AMENDMENT TO FACILITY OPERATING LICENSE

Amendment No. 111
License No. DPR-26

AMENDMENT NO. 111 TO FACILITY OPERATING LICENSE NO. DPR-26

SAFETY EVALUATION BY THE OFFICE OF NUCLEAR REACTOR REGULATION
RELATED TO AMENDMENT NO. 111 TO FACILITY OPERATING LICENSE NO. DPR-26
CONSOLIDATED EDISON COMPANY OF NEW YORK, INC.
INDIAN POINT NUCLEAR GENERATING UNIT NO. 2
DOCKET NO. 50-247

FIGURE 3.8-1
LIMITING FUEL BURNUP VERSUS INITIAL ENRICHMENT

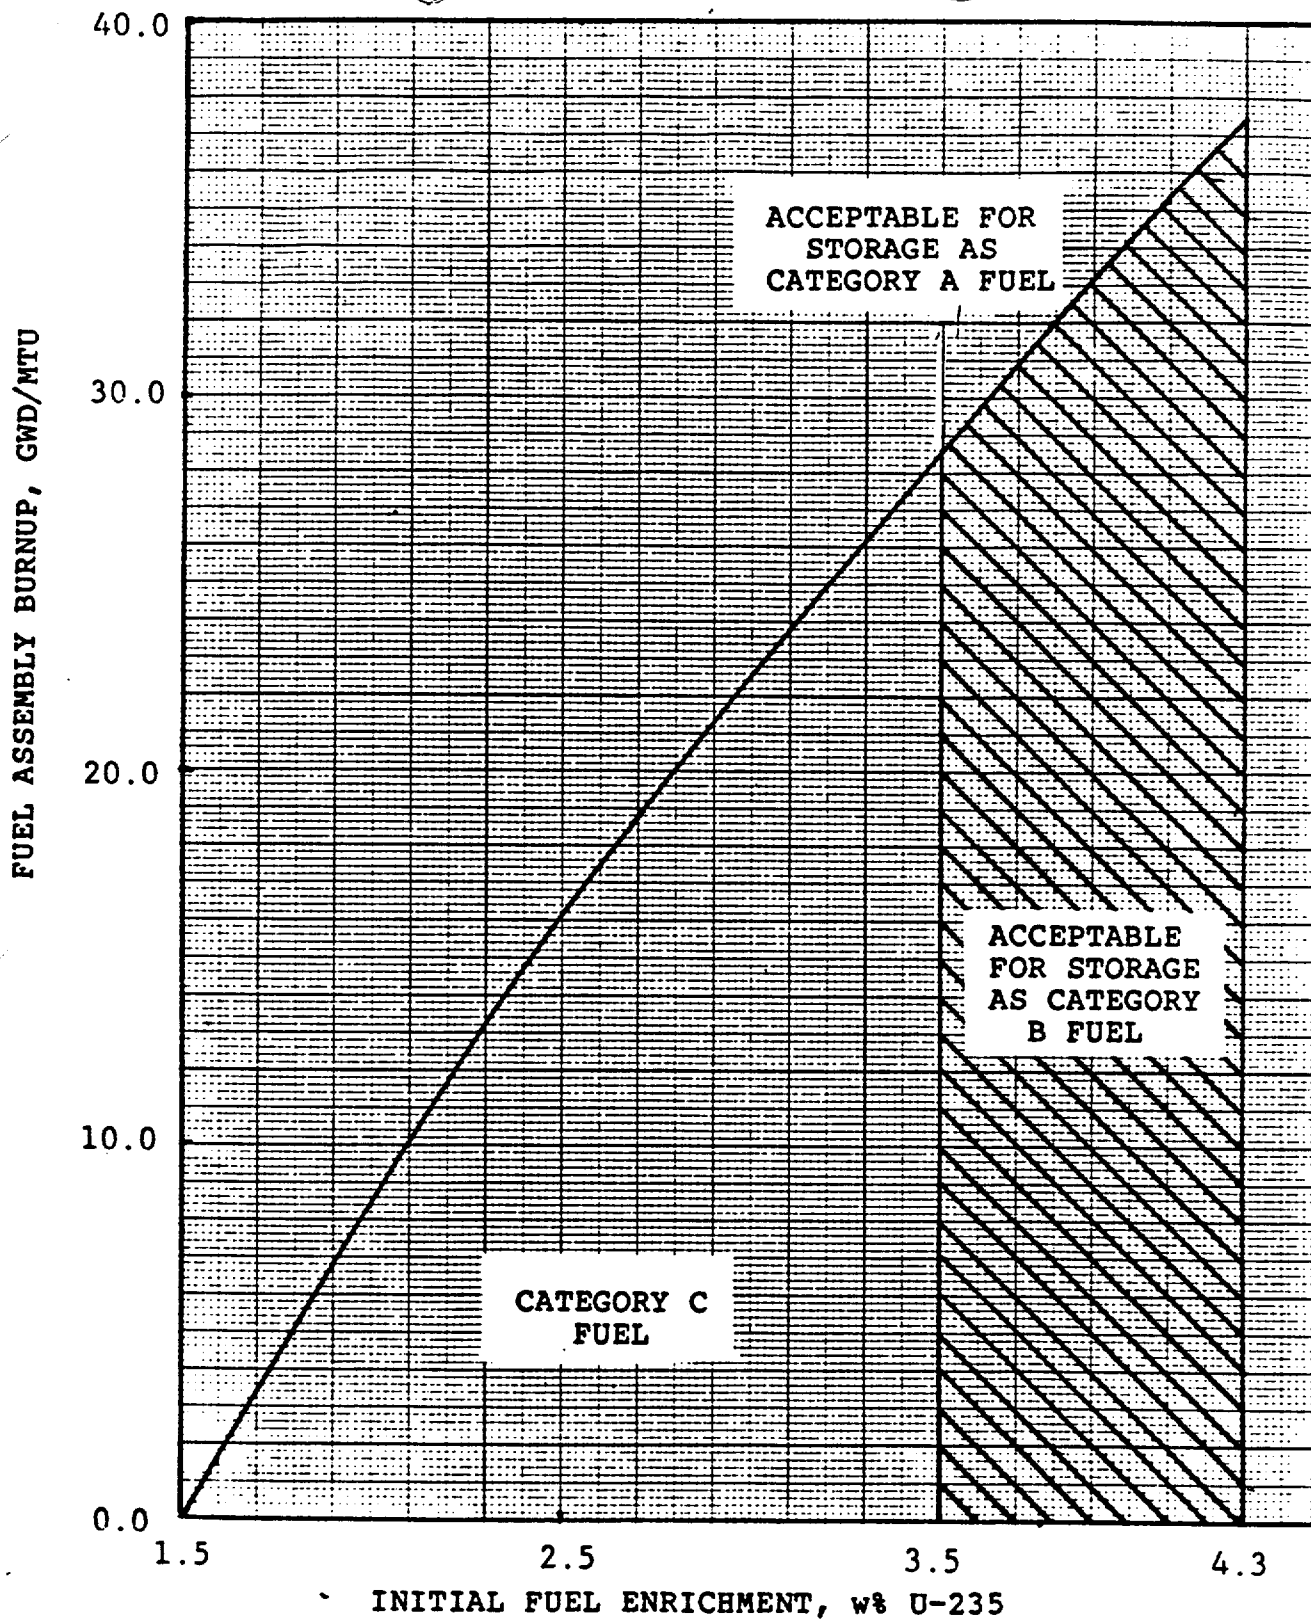
The fuel enrichment and burnup limits in Specification 3.8.C.1 assures the limits assumed in the spent fuel safety analyses will not be exceeded. Within this specification adjacent location means those four locations directly contacting the four sides (faces) of a fuel assembly but excludes those four locations which contact the four corners of a fuel assembly.

- 2.B. The spent fuel storage racks are designed and their loading maintained within the limits of Technical Specification 3.8.C.1, such that $K_{eff} \leq 0.95$ even if unborated water were used to fill the pit and with the fuel loading in the assemblies limited to 54.33 grams U-235 per axial centimeter of fuel assembly.

CATEGORY A - AREA ALONG THE CURVE AND ABOVE
 CATEGORY B - AREA BELOW THE CURVE AND $3.5 < \text{wt \% U-235} \leq 4.3$
 CATEGORY C - AREA BELOW THE CURVE AND $\text{wt \% U-235} \leq 3.5$

FIGURE 3.8-1

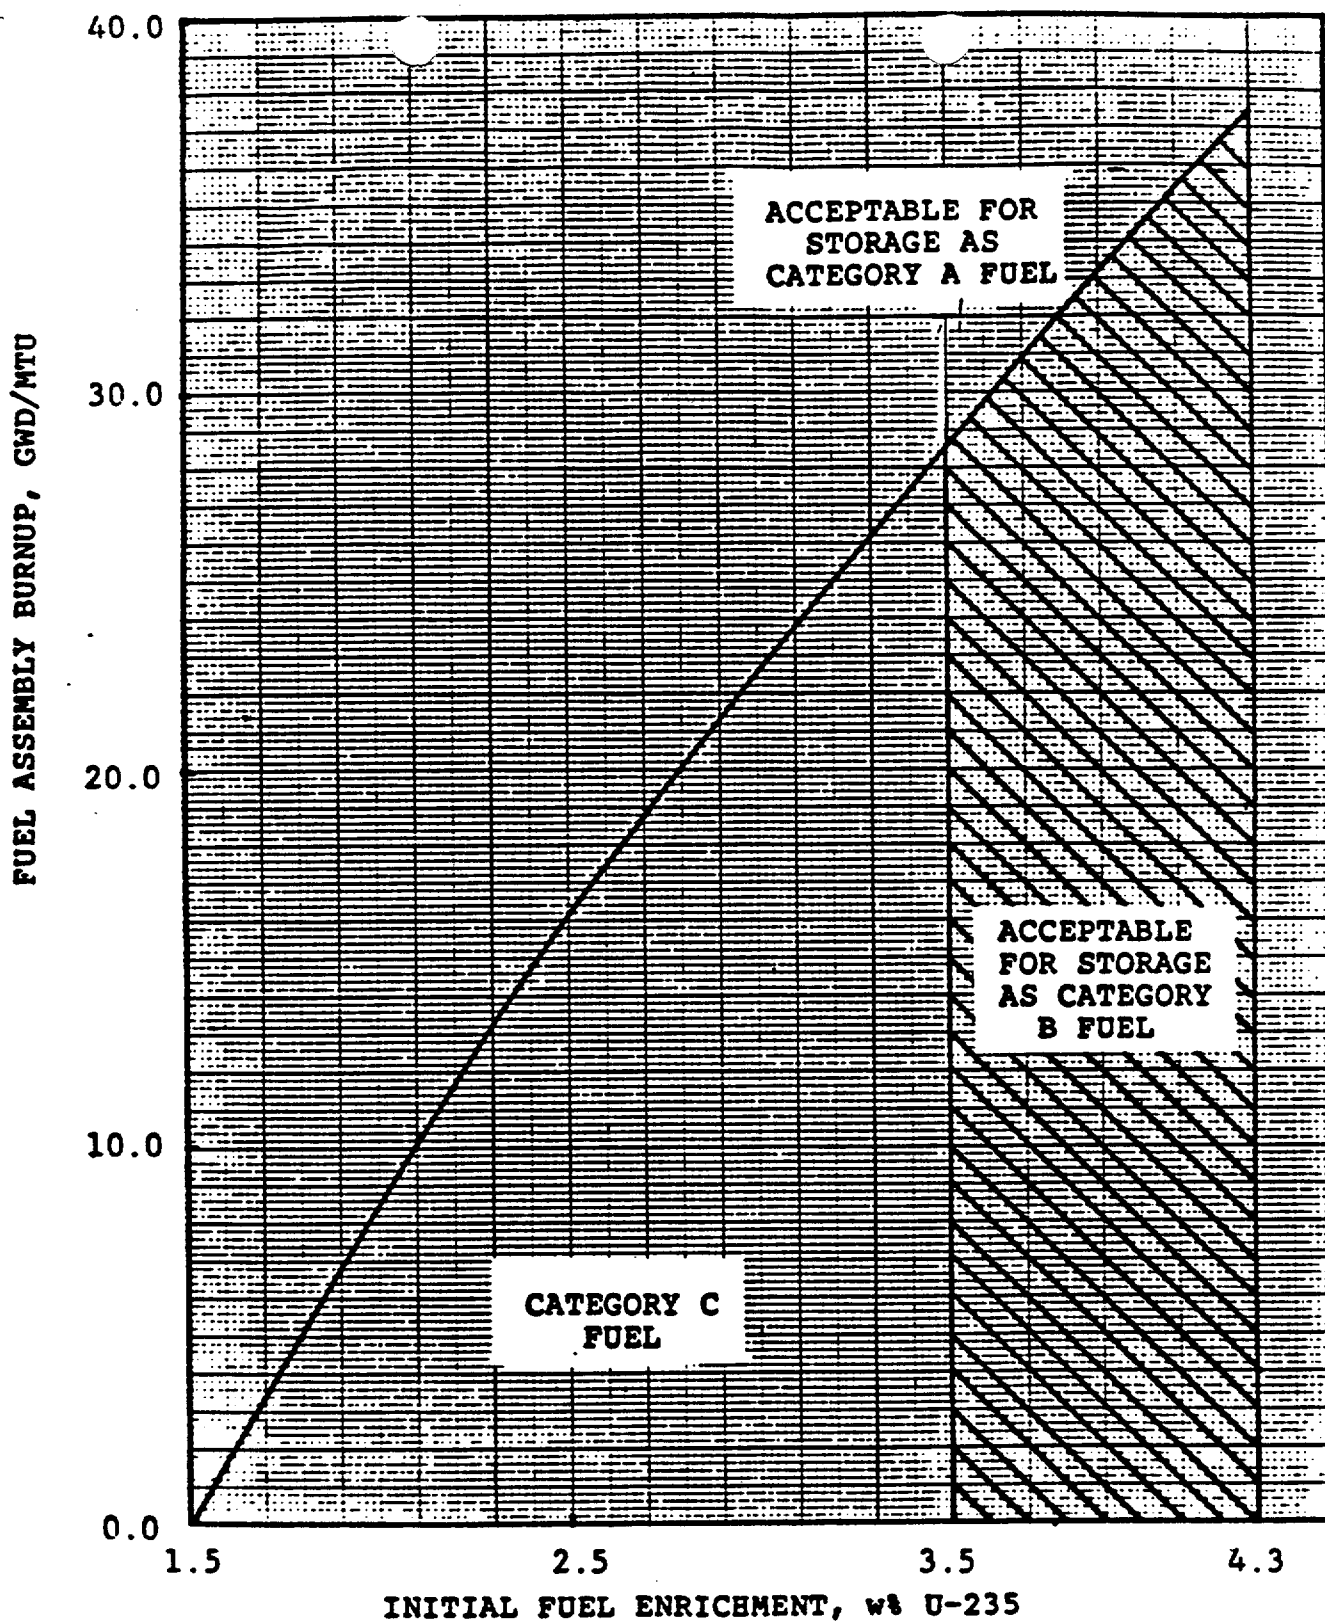
The new specification distinguishes three categories of fuel assemblies (A, B and C) as a function of burnup vs enrichment. The three categories are shown in Fig. 3.8-1 of the Technical Specifications, which is reproduced on the next page. Technical Specification 3.8.C.1 proposes to load category B assemblies in the spent fuel pool in a checkerboard pattern, neighboring (on the sides) only with category A assemblies. The category C assembly storage within the pool is unrestricted except that they cannot be loaded adjacent to category B fuel assemblies. This arrangement with the burnups and enrichment specified in Fig. 3.8-1 assures that the limits assumed in the safety analyses of the spent fuel pool will not be exceeded. The substantive change is the increase of the initial fuel enrichment from 3.5 to 4.3 w/o U-235. The checkerboard loading pattern will maintain $k_{eff} \leq .95$ as provided in section 9.1.2 of the Standard Review Plan. The k_{eff} estimate is discussed in paragraph 2.4 below.

The methodology, in this calculation used the CASMO-2E and PDQ-7 codes (References 4 and 5) to assess enrichment vs depletion. The CASMO-2E solution for the Indian Point 2 pool was used to benchmark the calculation against the original (reference) calculation and to provide macroscopic cross sections for non fuel regions for use in the PDQ-7 code. (References 9 and 10). Depletion dependent macroscopic cross sections as a function of initial enrichment, were used which in turn were used to derive burnup as a function of initial enrichment for a constant k_{eff} . CASMO fuel rack and fuel assembly models were developed, which generated the necessary cross sections for a PDQ-7 rack and fuel assembly model. The last was applied to determine the checkerboard arrangement of 4.3 w/o U-235 and depleted assembly loadings. This process yielded Fig 3.8-1 shown previously.

assemblies was carried out on a 4 1/4 assembly configuration with reflecting boundary conditions. Two of the 1/4 assemblies were 4.3 w/o U-235 and the other two were depleted. The k_{eff} value in Figure 3.8-1 at 1.5 w/o U-235 and zero burnup is .906. Then this k_{eff} was held constant for increasing burnup and enrichment. In this manner the category A fuel is determined to be above the $k_{eff} = .906$ line. A justification of the biases and uncertainties of the calculation was submitted in the additional information (Reference 3). The uncertainties and biases were conservative and, hence, acceptable.

CATEGORY A - AREA ALONG THE CURVE AND ABOVE
 CATEGORY B - AREA BELOW THE CURVE AND $3.5 < \text{wt U-235} \leq 4.3$
 CATEGORY C - AREA BELOW THE CURVE AND $\text{wt U-235} \leq 3.5$
